SPR EA1N and EA2 PROJECTS

DEADLINE 9 – COMMENTS ON CAH3 SUBMISSIONS

Interested Party: SASES PINS Refs: 20024106 & 20024110

Date: 15 April 2021 Issue: 1

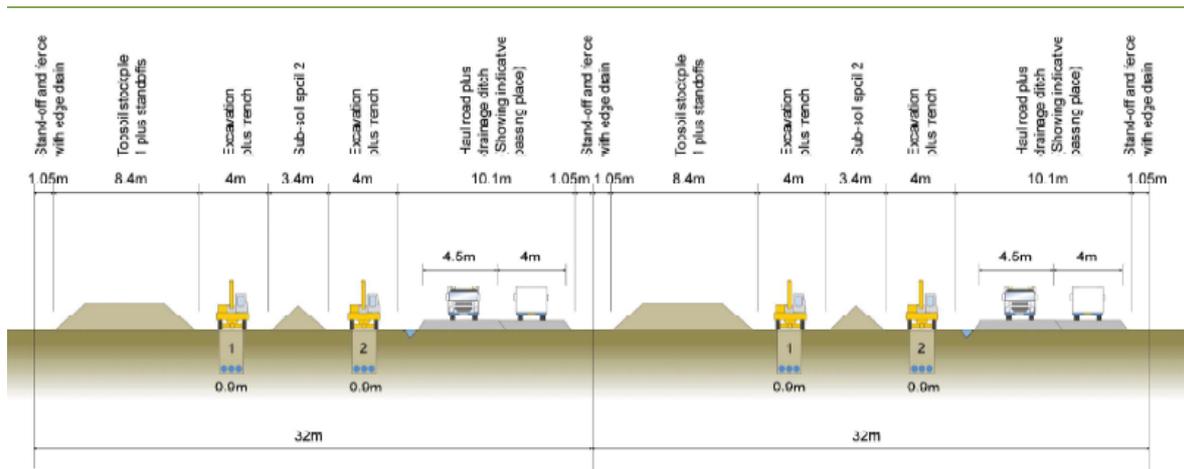
17. The Applicants' explanations at CAH3 regarding their intention to acquire rights over excessive areas of land along a 70m width of the Cable Corridors were confusing.

18. In their response to Action Point 3, the Applicants claim that a single consented 70m wide order limit shared by both projects is justified through a potential benefit to agricultural landowners should only one project be consented. The Applicants argue in section 2.2 that in that scenario there would be flexibility ensuring that the single cable corridor can be constructed adjacent to the field boundary, thereby avoiding the need for a landowner to leave sterile during construction phases a 35 metre wide strip of land between cable corridor and field edge.

East Anglia TWO and East Anglia ONE North Indicative cable trenching arrangement and working area

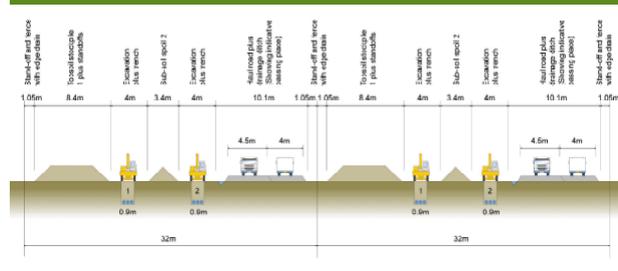
20. The Applicants did not describe or illustrate at CAH3 their Indicative Cable trenching arrangement and working area to include two separate haul roads in the event that 'Scenario 1' prevails i.e. EA1N and EA2 constructed concurrently. This default arrangement was illustrated by SPR on Display Boards at its final and formal Phase 4 / Section 42 public consultation : Slide 2 of Appendix 9.10 of 5.1.9 Phase 4 Public Exhibition Boards [[APP-038](#)] as illustrated below and attached.
